**PUBLIC INTEREST REVIEW FOR GROUNDWATER APPLICATIONS**

SUBJECT: Application G- 17604 Reviewer's Name \_\_\_\_\_  
Supersedes review of \_\_\_\_\_ Date of Review(s) \_\_\_\_\_

**A. GENERAL INFORMATION:** Applicant's Name: NF Land LLC County: Umatilla

# Groundwater Application G-17604, NF Land LLC Umatilla County, Bowlus Hill Quad

### WALLA WALLA SUB-BASIN - UMATILLA BASIN OWRD LOGID UMAT 55891 06N/035E-16DDC

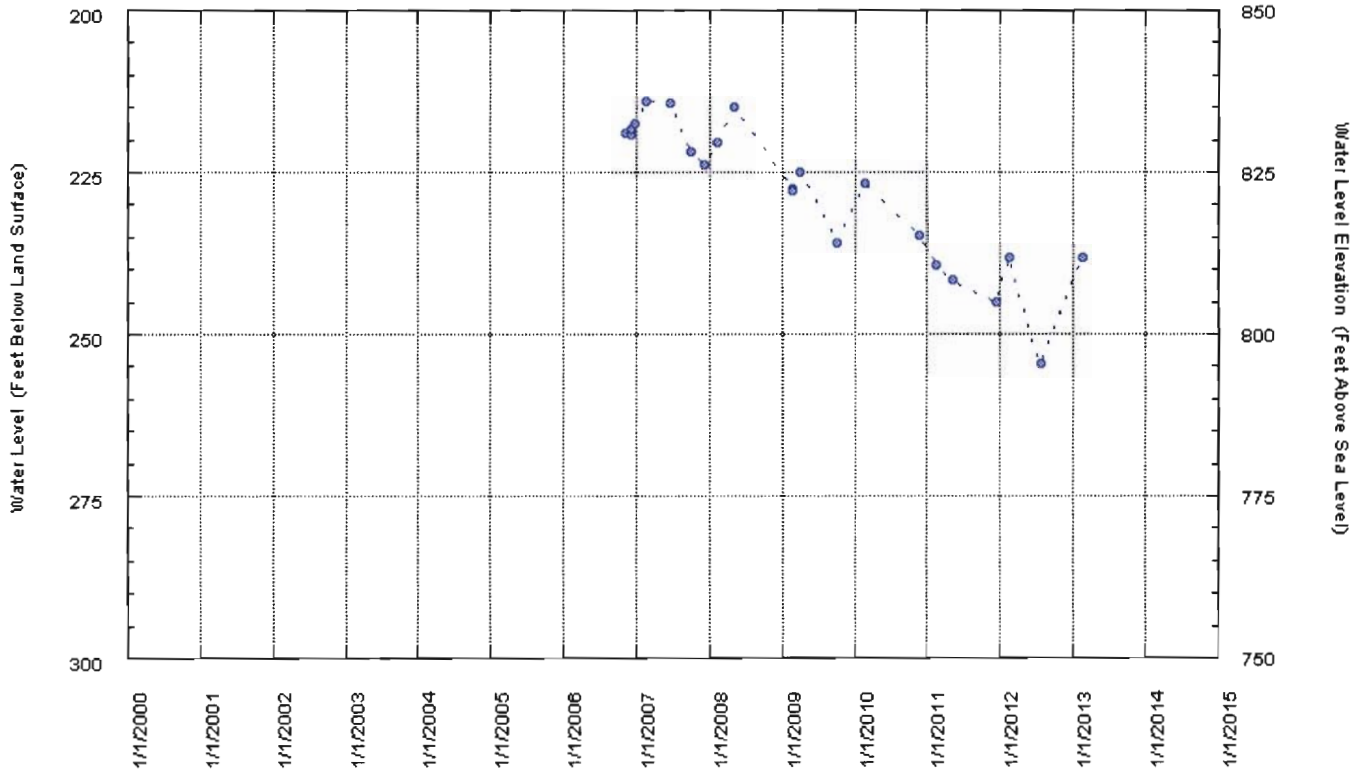
B3. Groundwater availability remarks: **The applicant is requesting 6.47 cfs (2900 gpm) from 15 wells for irrigation of 517.7 acres. Wells 1 – 14 are PROPOSED, well #15 has been constructed but the well constructor did not file a Water Well Report. Wells 1 - 7 are located outside of the five-mile radius from City of Milton-Freewater wells and wells 8 – 15 are within the five-mile radius. Aquifers within the Columbia River Basalt Group are capable of producing 2900 gallons per minute in many areas of the Umatilla Basin. The problem is that these same aquifers cannot sustain that amount of development without declines occurring. Declines have been documented in basalt aquifers in the Umatilla Basin and in the Walla Walla sub-basin. An example would be UMAT 55891, a well that develops water from an aquifer in the Columbia River Basalts. See attached hydrograph. UMAT 55891 is the POA for permits G-15862 and G-16445. The permits are for irrigation of 104.7 and 104.9 acres respectively. Use of the well began in 2008. From**

**February 2008 to February 2013, the groundwater level has declined 24 feet. Average pumpage was 1.7 acre-feet per acre for the first couple of years as only half of the land was irrigated. The groundwater resource cannot sustain the requested rate and quantity requested by this application. Groundwater levels in the many other wells in the area have significant groundwater level declines.**

A permit could be issued if the amount of water for this project was reduced to 210 acre feet annually. The proposed well construction will need to be modified so that when complete there will only be 100 feet of open borehole unless additional work is done to show that there is only one aquifer being developed.
